Town of Hilton Head Island
Design Review Board Special Meeting
Tuesday, September 22, 2020 – 1:15 p.m.
AGENDA

i. Mitchelville Lot 11, DRB-001801-2020

i. Shelter Cove Railings Replacement, DRB-001792-2020

i. William Hilton Parkway Self Storage, DRB-001794-2020

Conceptual Site Plan

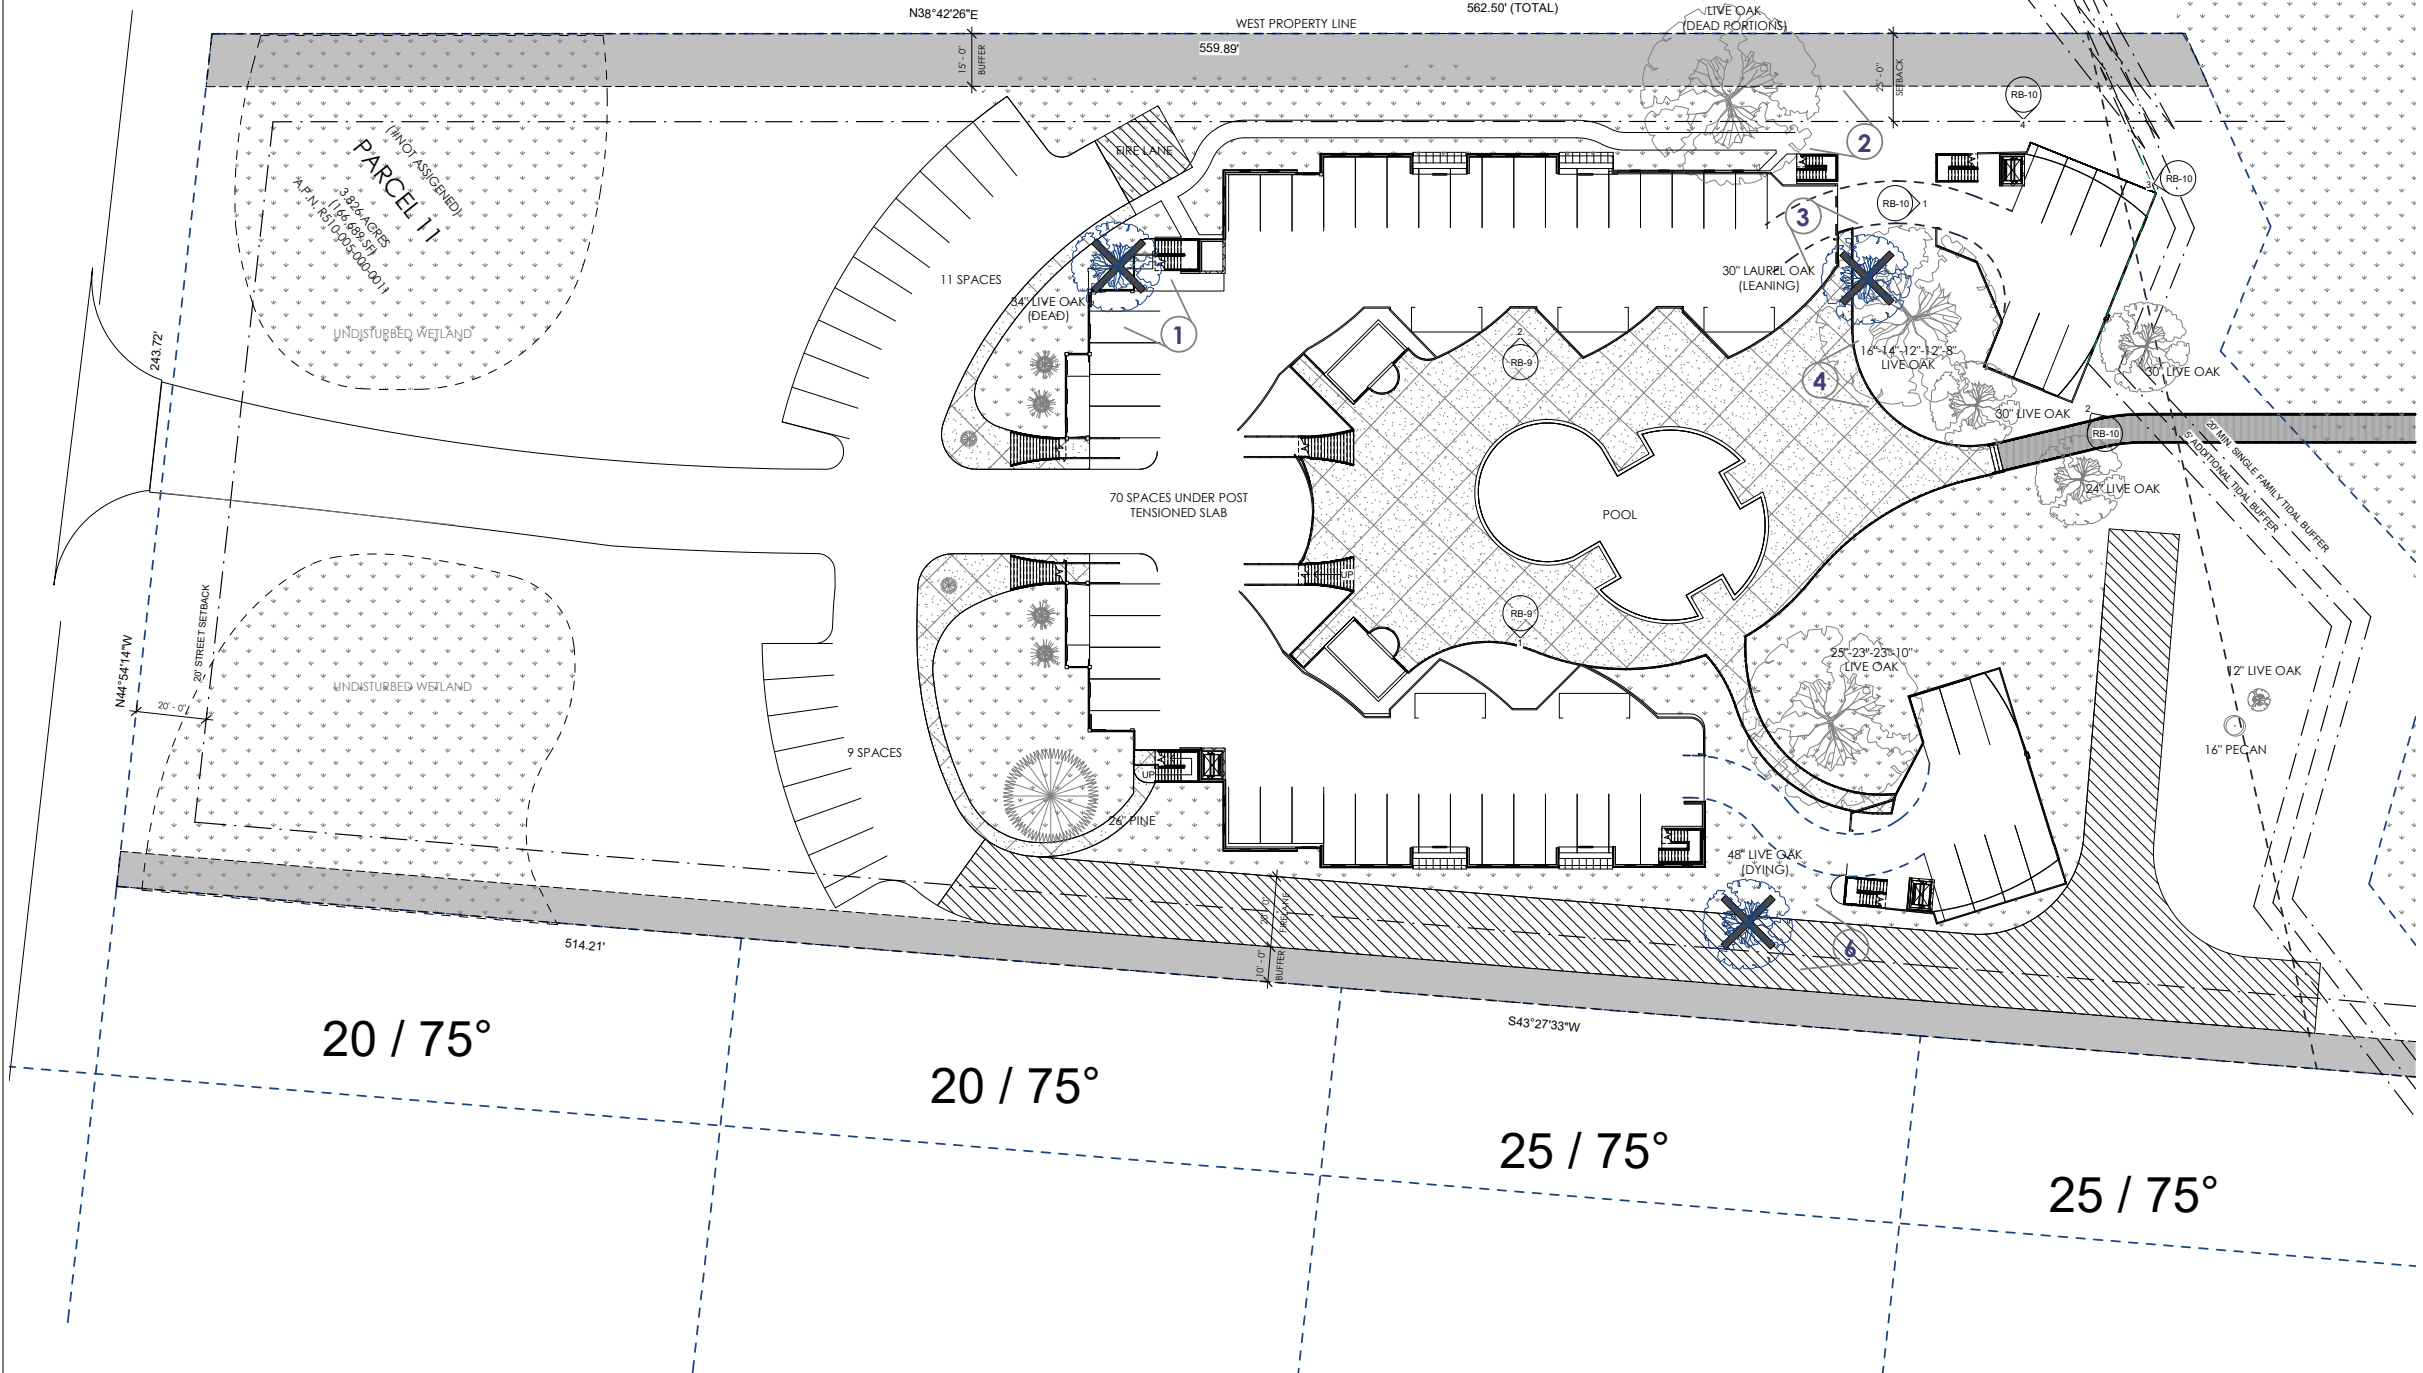
1. The project was last reviewed at the Aug. 21st DRB meeting and withdrawn by the applicant prior to a vote by the DRB.
2. The site plan does not show the dumpster location per its description during the Aug, 21st review.
3. During the Aug. 21st review, the DRB suggested a planting area between the front stairs and garage entrance.
4. The parking spaces in the separated units on the ocean side appear to be difficult for vehicular access.
5. Where is the location of the proposed stormwater detention?

DRAWING TITLE
SITE PLAN

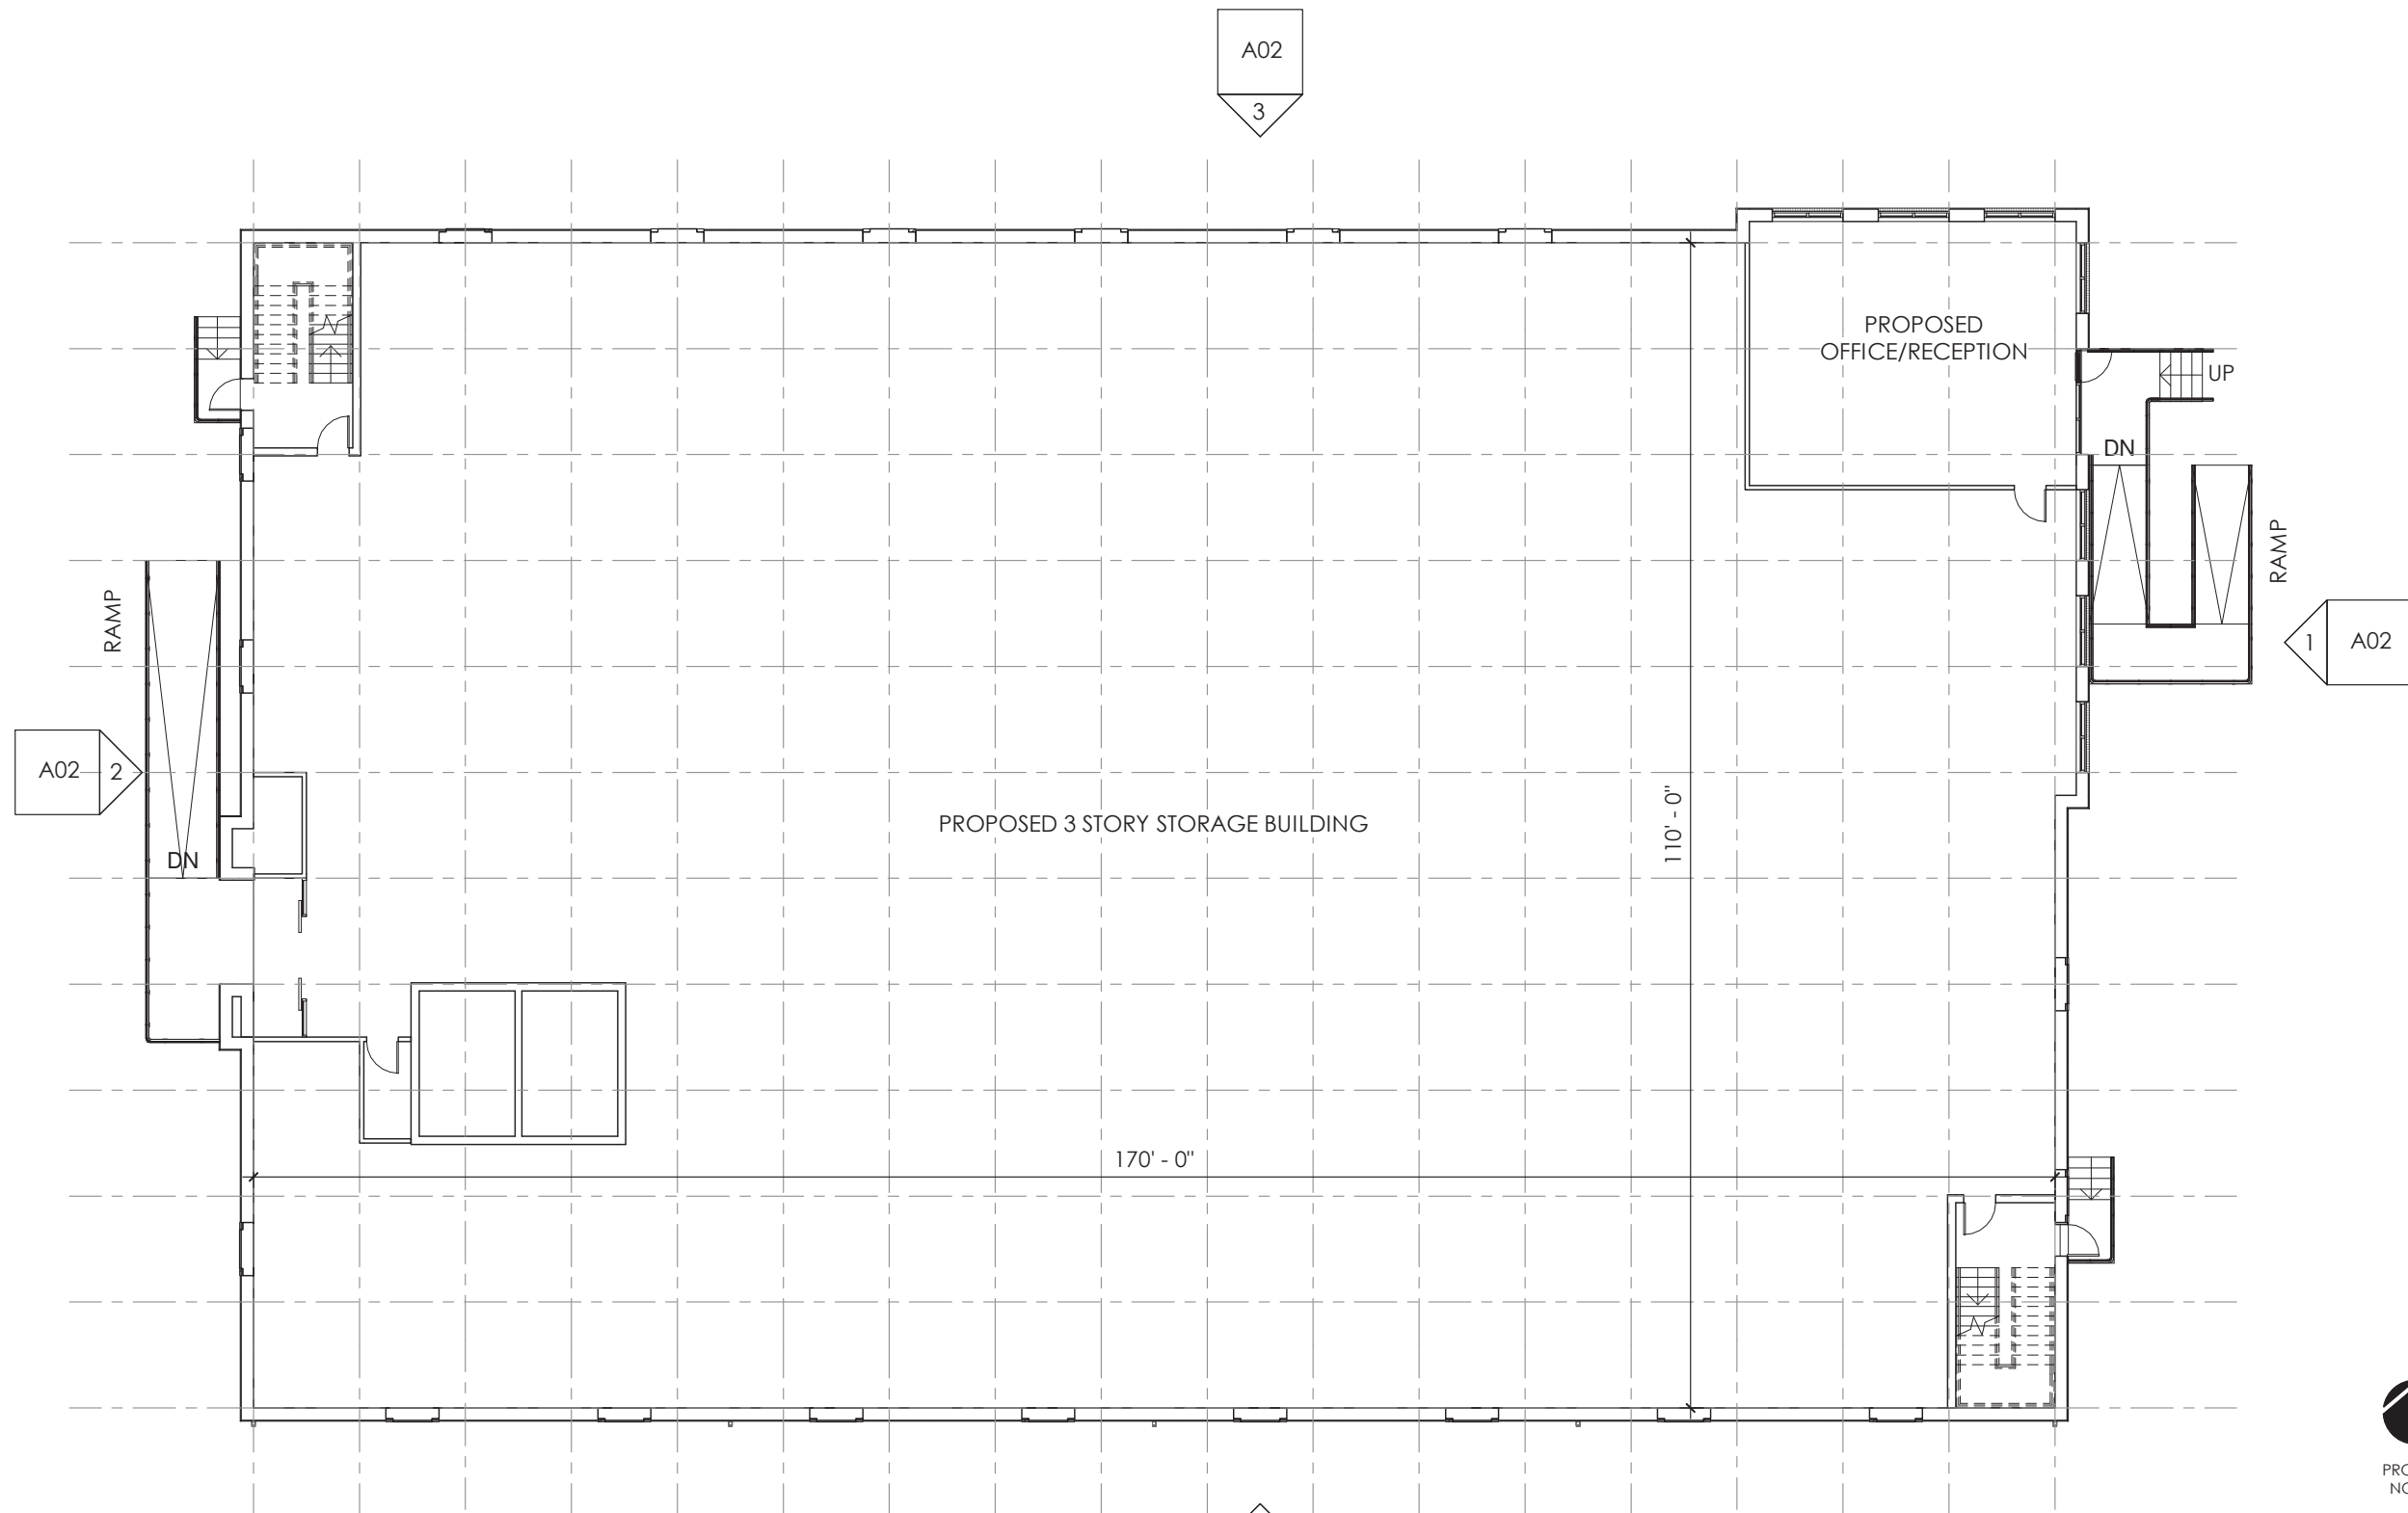
2. The site plan needs further consideration. The site plan and parking lot seem to be afterthoughts. <ol style="list-style-type: none"> a. the entrance off Dunnagans Alley is at an odd angle. b. the perimeter fence obstructs the parking lot flow at Dunnagans Alley. c. provide landscape area along the fence at the Dunnagans Alley entrance. d. "Outdoor Storage" must meet the requirements listed, including but limited to, of LMO Sec. 16-4-103, E.5

3. Provide for planting area along the Dunnagans Alley perimeter fence and at the back of Phase One and Phase Two.
4. Provide a dimensioned detail of the perimeter fence. Because it is within the setback on Dunnagans Alley it cannot exceed 4' height. Staff recommends an opaque fence detail. Chain link will not be acceptable.

① SOUTH ELEVATION
1" = 20'-0"

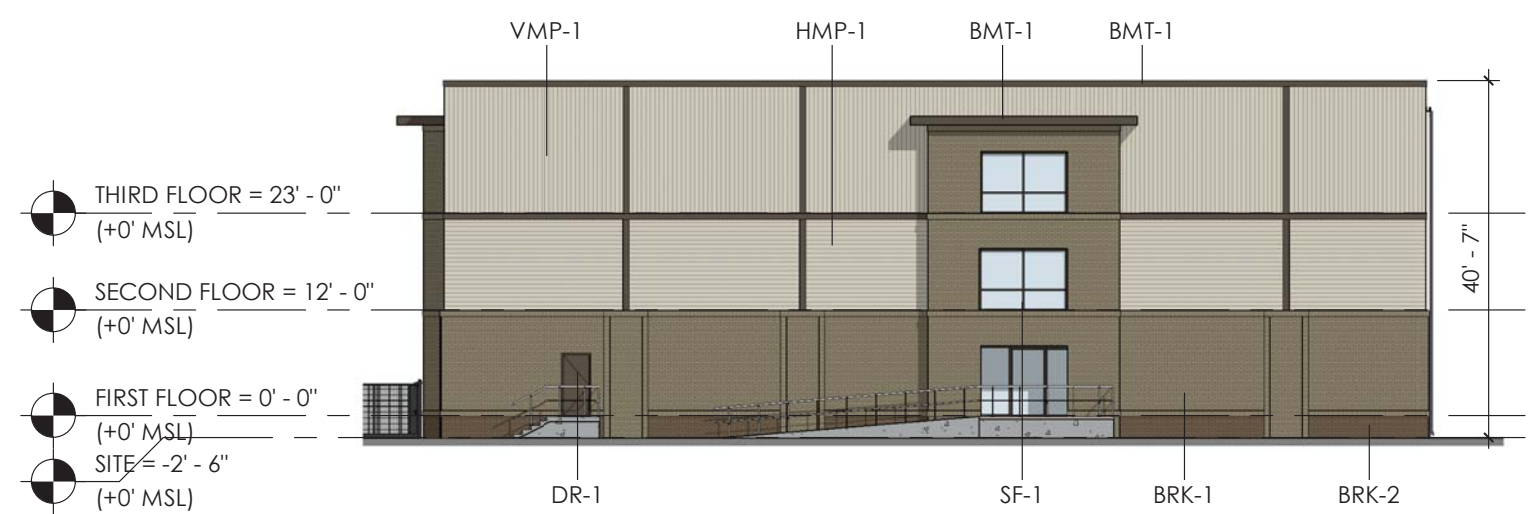
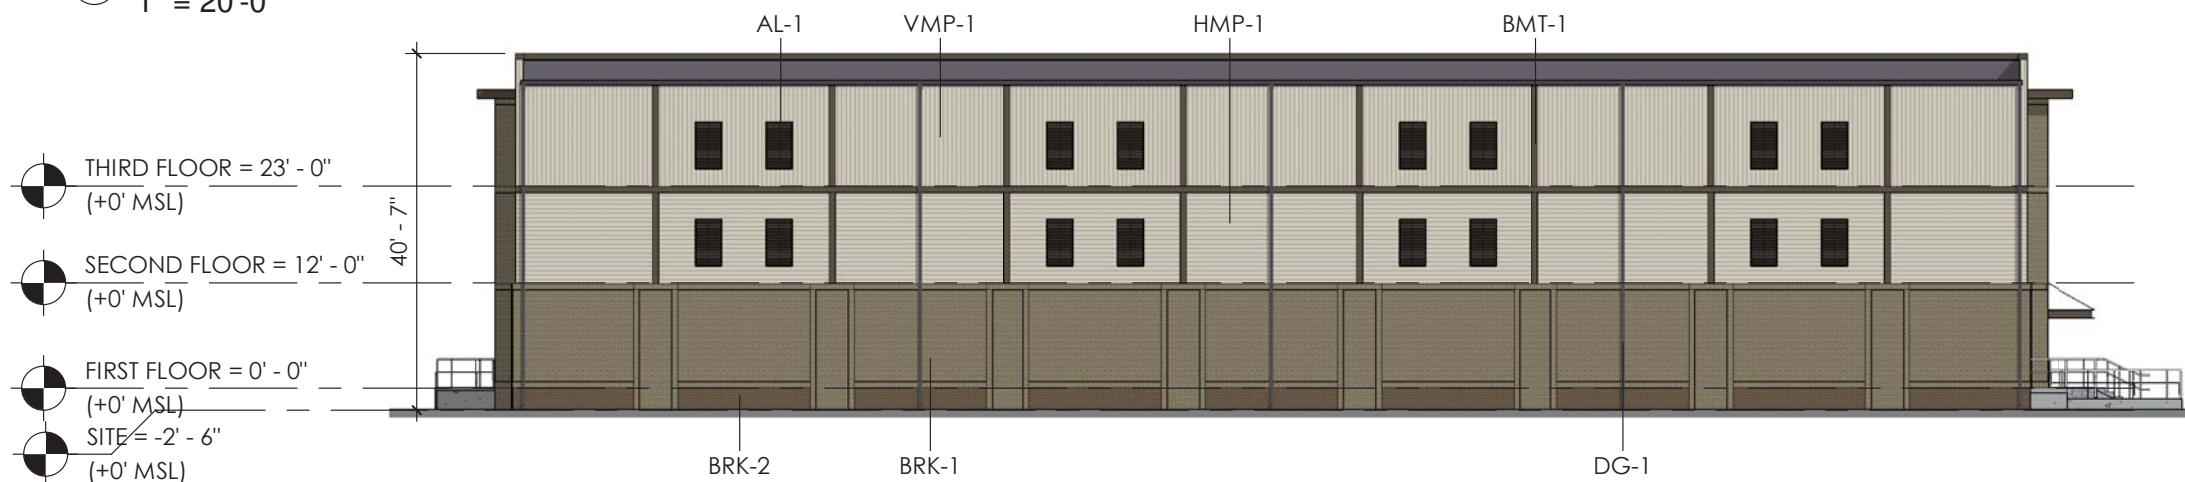
DESIGN GUIDE/LMO CRITERIA	Complies Yes	No	Not Applicable	Comments or Conditions
Structure is designed to be appropriate to the neighborhood	<input type="checkbox"/>	<input checked="" type="checkbox"/>	<input type="checkbox"/>	The building lacks the human scale and architectural detail of the adjacent structures.
Promotes pedestrian scale and circulation	<input type="checkbox"/>	<input checked="" type="checkbox"/>	<input type="checkbox"/>	The building lacks architectural detail that would give it more of a pedestrian scale and pedestrian circulation and the front building entrance are obscure.
Utilizes natural materials and colors	<input type="checkbox"/>	<input checked="" type="checkbox"/>	<input type="checkbox"/>	Per the Design Guide, page 16 "Context", "Colors shall not be used to cause the structure to stand out from other or its background." The proposed brick and siding color is too light. Staff recommends a more nature blending color scheme.

All facades have equal design characteristics	<input type="checkbox"/>	<input checked="" type="checkbox"/>	<input type="checkbox"/>	Per the Design Guide, page 12 “Architecture”, “all sides of a structure should be given the same design consideration as the entrance or street façade.” The Dunnagans Alley elevation is void of any real architectural detail and the sides of both Phase One and Phase Two appear to be blank as well.
Avoids monotonous planes or unrelieved repetition	<input type="checkbox"/>	<input checked="" type="checkbox"/>	<input type="checkbox"/>	Per the Design Guide, page 13 “Form”, “The form or shape of structures should avoid monotonous unbroken planes or unrelieved repetition of shape. Visual interest and shadow play can be created by several techniques including the use of offsetting planes with a variety of depths.” Both Phase One and Two have monotonous unbroken planes.

Has a strong roof form with enough variety to provide visual interest	<input type="checkbox"/>	<input checked="" type="checkbox"/>	<input type="checkbox"/>	Per the Design Guide, page 13 “Form”, “Typically gable, hip or shed roof forms are desirable with a minimum pitch of 6/12. In larger structures a variety of forms can provide greater visual interest and break up large roof planes.” Pitch roof elements should be added to Phase One and given the size of Phase Two, Staff suggest it should have a gable roof.
Minimum roof pitch of 6/12	<input type="checkbox"/>	<input checked="" type="checkbox"/>	<input type="checkbox"/>	See above
Overhangs are sufficient for the façade height.	<input type="checkbox"/>	<input checked="" type="checkbox"/>	<input type="checkbox"/>	Most of the Phase One and all of Phase Two lack any overhang.
Forms and details are sufficient to reduce the mass of the structure	<input type="checkbox"/>	<input checked="" type="checkbox"/>	<input type="checkbox"/>	Per the Design Guide, page 13 “Mass”, “The structure shall not be of such mass that is dominates its surroundings or adjacent development. Architectural form and detailing must be used to reduce the appearance of the mass of the structure.”
